WATERSIDE PLACES

STAGE 4 ACOUSTIC DESIGN REPORT

ISLINGTON WHARF PHASE 4

AEC REPORT: P3725/R02d/AGB

IPW02 - Apartment to Apartment

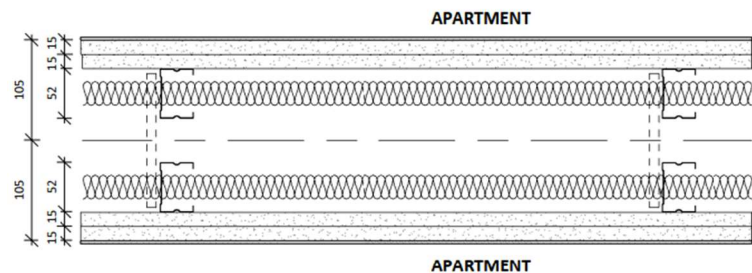
- 6.5 The BG White Book indicates that this construction would achieve a performance of approximately $63\text{dB}_{\text{R}_{\text{W}}}$ and $56\text{dB}_{\text{R}_{\text{W}}+\text{C}_{\text{tr}}}$ (System ref: A216009S). Subject to confirmation with British Gypsum, at this stage, if there is a requirement to brace the twin metal frames, an acoustic brace should be used.

- 6.6 Provided that acoustic braces are used, the above wall should achieve the Clients requirements of $\text{ADE} +5\text{dB}$ i.e. $50\text{dB}_{\text{D}_{\text{NT},\text{W}}+\text{C}_{\text{tr}}}$.

- 6.7 Socket boxes should be fitted with a putty pad as a minimum and should not be located back to back (they should be located in the adjacent studwork bay as a minimum). Where only a minimum separation can only be provided, a putty pad will not suffice and a heavier-weight socket box (e.g. SRS Robust Detail socket box) must be used.

6.8 IPW02 - Apartment to Apartment.

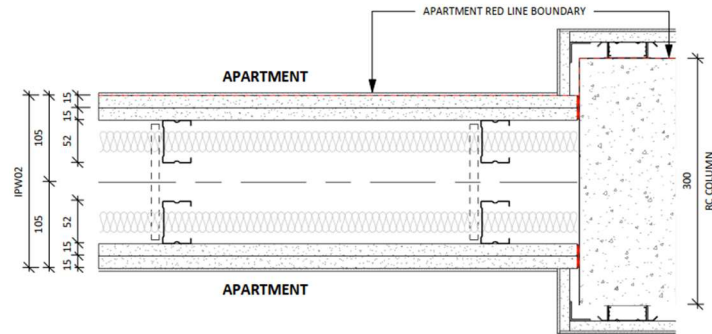
6.9 The above column detail is appropriate. It is assumed that where the party wall lining abuts the column, a mastic seal will be provided. If desirable, for a 300mm wide column, a dot and dabbed plasterboard finish could be used.

6.10 The junction between the column and external wall is subject to review by AEC.

IPW01 – Apartment to Communal

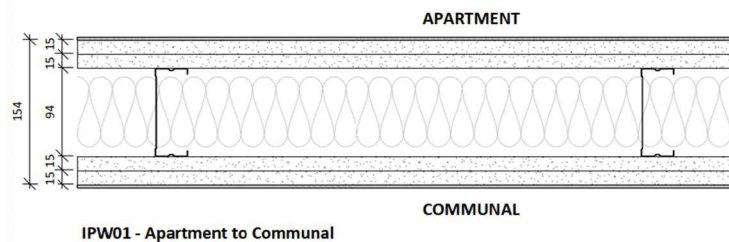
6.12 With reference to the BG White Book the above construction achieves 56dBR_w (System ref: A206234).

- 6.13 Although this partition would not meet the client's requirements of ADE +5dB and potentially may not comply with normal ADE requirements, in all instances there is a door in this partition to habitable spaces.

- 6.14 The composite SRI of the door and partition combined is around 37dB with the door being the weakness. Calculations show that there would be no benefit whatsoever in increasing the sound insulation performance of this partition.

- 6.15 As only noise from voices is anticipated in corridors the wall is also considered appropriate to bathrooms. Hence, the partition is considered appropriate in terms of acoustics.

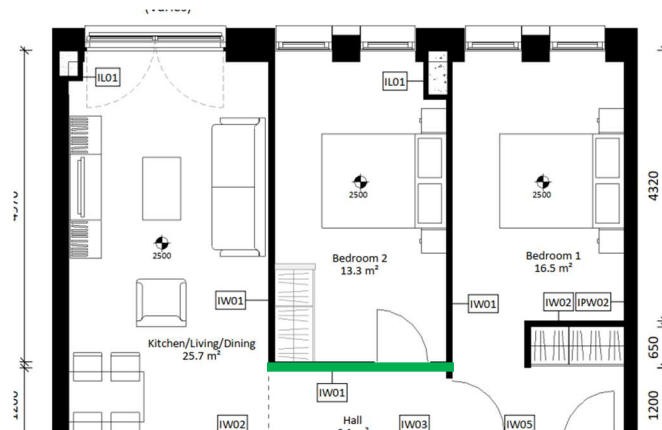
- 6.19 BG White Book – 42dB_{Rw} (System ref: A206045). Where this wall contains a door, consideration could be given to omitting the mineral wool. E.g. the wall marked green below.

Figure 6.1 – Examples of in principle Junction Details

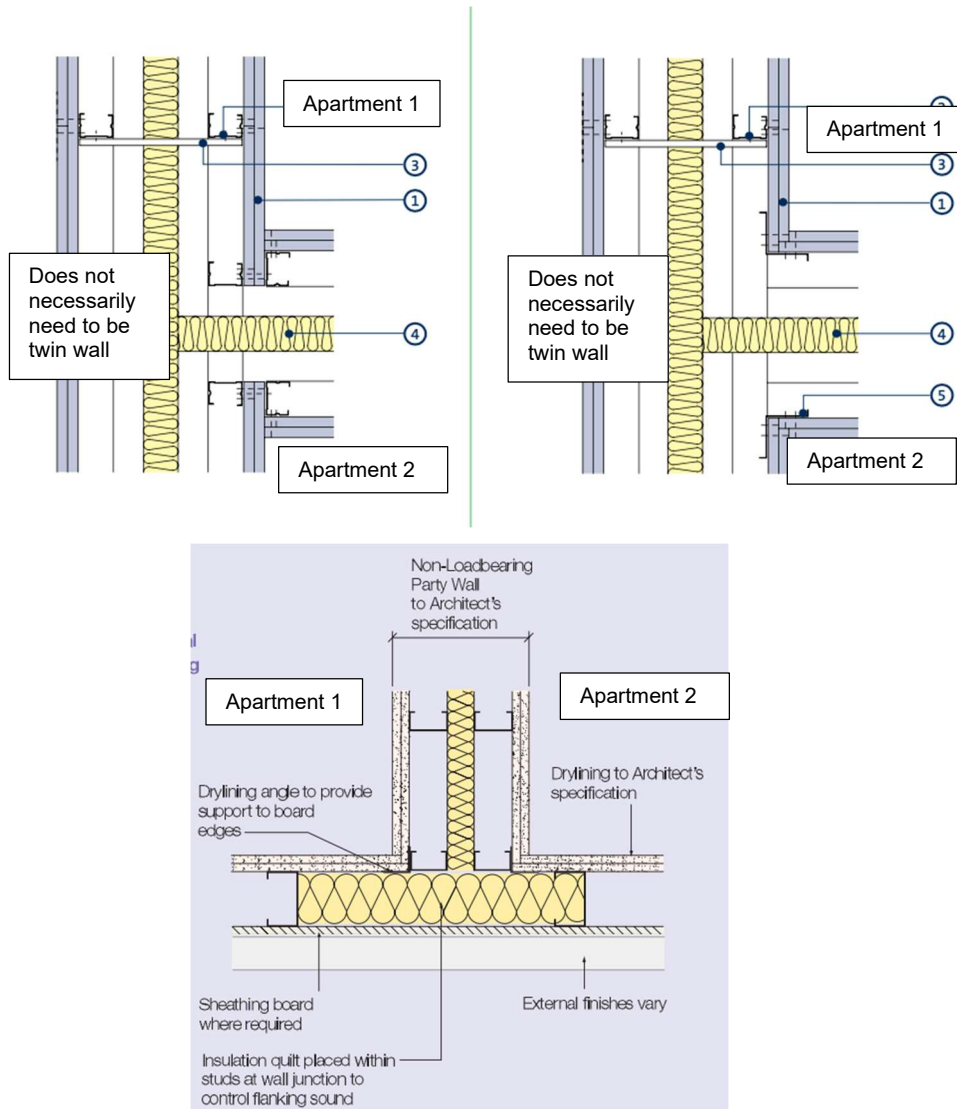
- 6.52 In principle junction details for separating party walls are presented in Figure 6.1 below.

- 6.53 Deflection head details must be correctly specified and constructed and the plasterboard forming the wall must overlap the core board by at least 10-15mm, where a deflection head detail is located above (and hence protected by) a plasterboard MF ceiling.
- 6.54 It is important that there are no gaps under the partition; even hairline gaps formed by small imperfections in a concrete floor can significantly reduce the performance of the partition. As such, where floors are not completely level and free of debris, it may be necessary to install C channels on a line of mastic before fixing to the floor.

Figure 6.2 – Alterations to Curtain Walling Detail

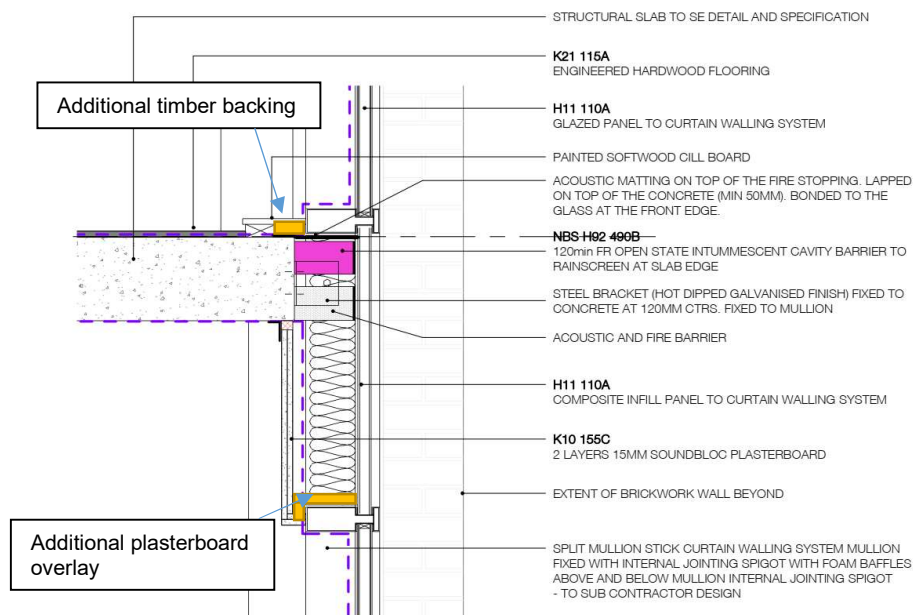
- 6.56 In terms of the curtain walling detail between the ground floor and first floor apartments, an additional batten should be provided to add more mass to the cill and the bottom mullion should be overlaid with a later of 15mm thick Soundbloc (simply adhered using mastic) as identified in Figure 6.2 below.
